ADDENDUM LETTER

HAMPTON CARPORT PLANS
COLUMBIA COUNTY, FL
Signed and sealed on 8 MAR 2018

PLANS FOR
HAMPTON CARPORT
COLUMBIA COUNTY, FL

FLOOR PLAN

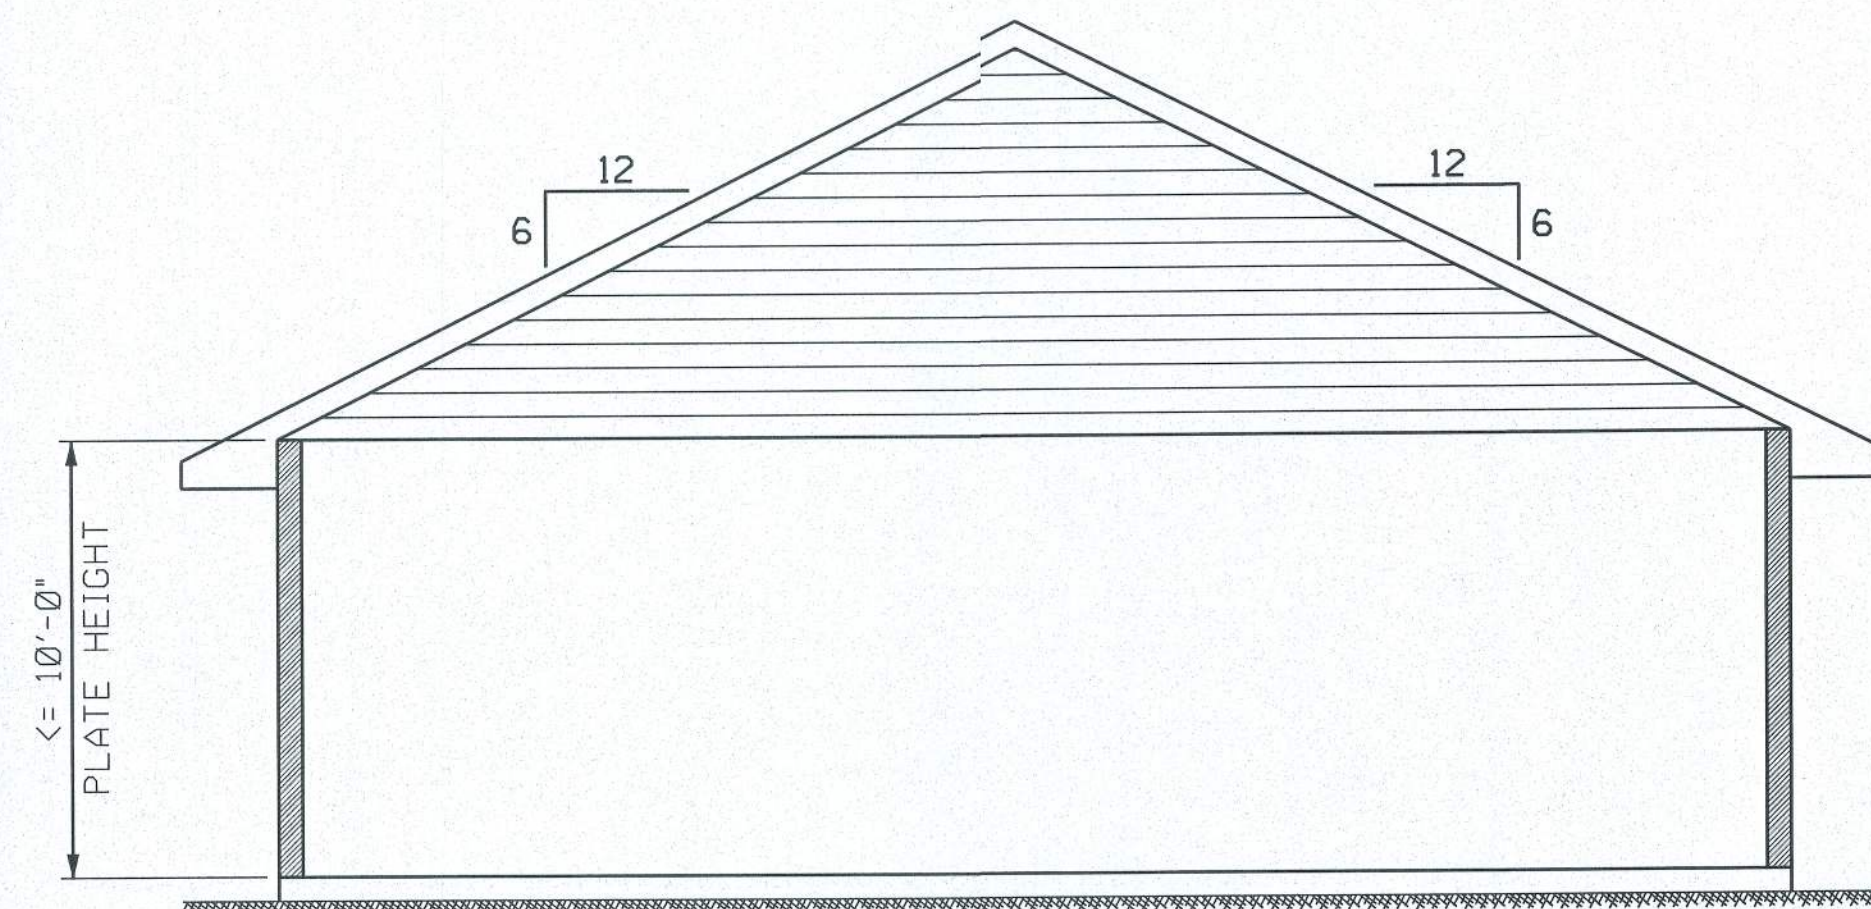
1. Structure to be modified from 32'x36' to a 32'x40' with post spacing changed from 9' to 10'.
2. Beams shall be 2 - 1.75" x 9.25" LVL (1.9E 2850 Fb) min.
3. Install Simpson CCQ46SDS2.5 at each column to beam connection.
(ECCQ46SDS2.5 may be installed at end columns)
